Code Amendment Proposal Form

For public amendments proposed to the 2021 editions of the International Codes

1007.1.1 Two exits or exit access doorways

GRAPHIC 1

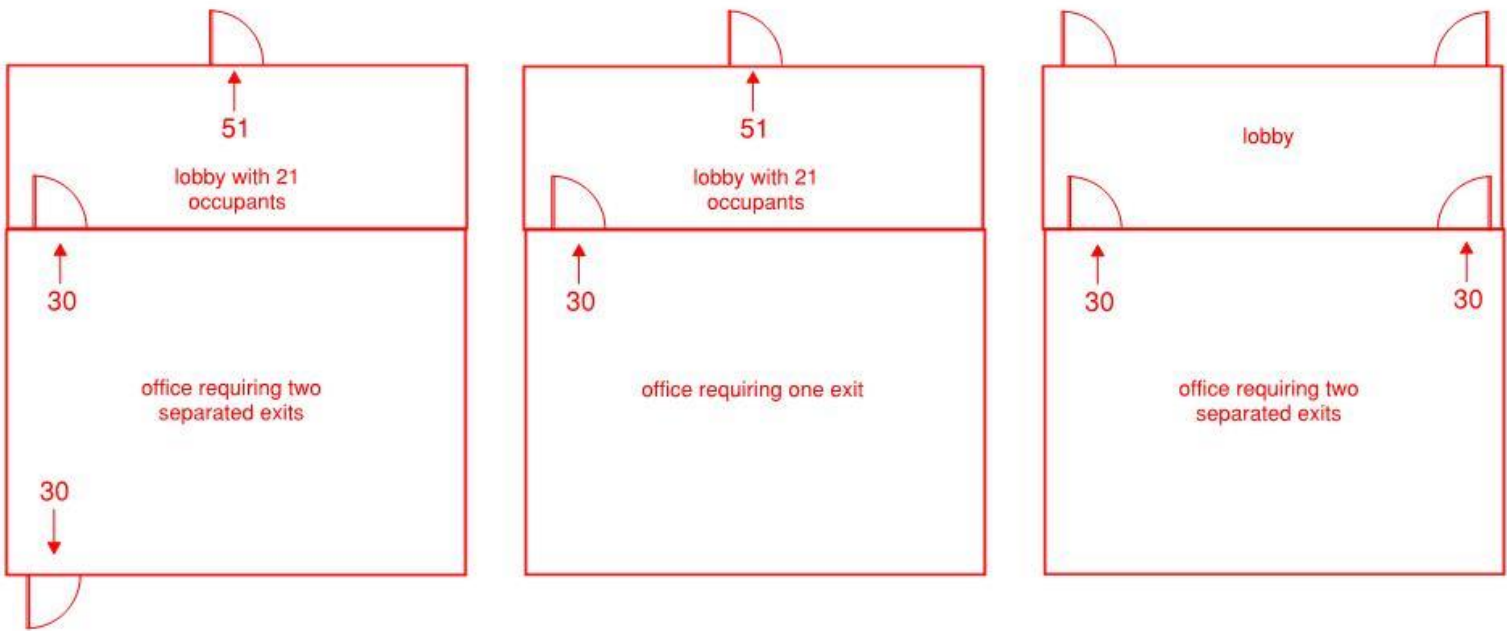
The intent of this amendment is to prohibit convergence of egress paths illustrated above

GRAPHIC 2a

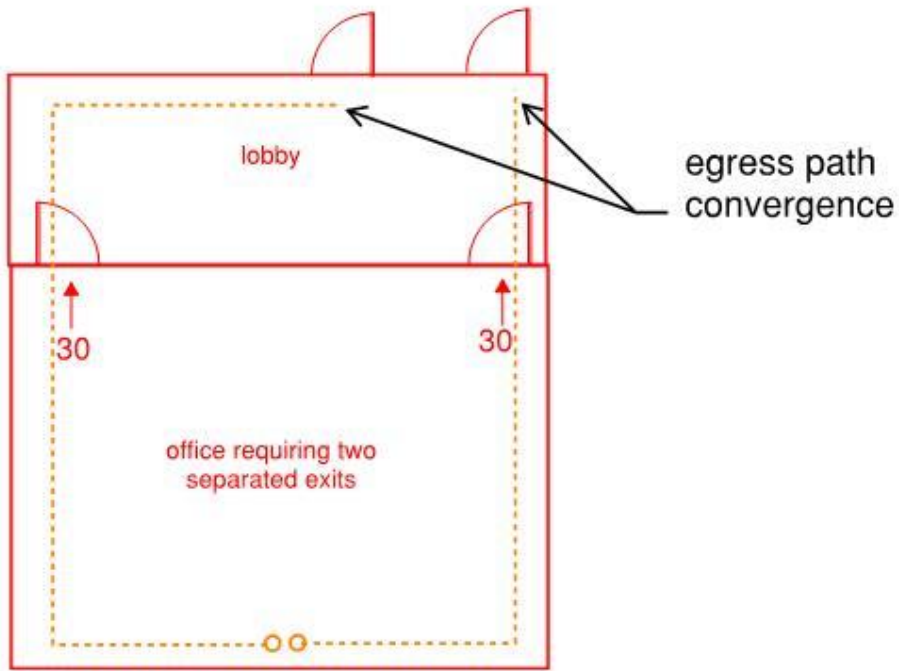
All of the above configurations are compliant with both 1006.2.1 Exception 1 and this amendment. This proposal only requires exit separation be maintained where already required from a space needing two exits. This is consistent with the commentary language to 1006.2.1 Exception 1, which states: "It should be noted that where two doorways are required, the remoteness requirement of Section 1007.1 is applicable." The counter-argument would allow that on page 2.
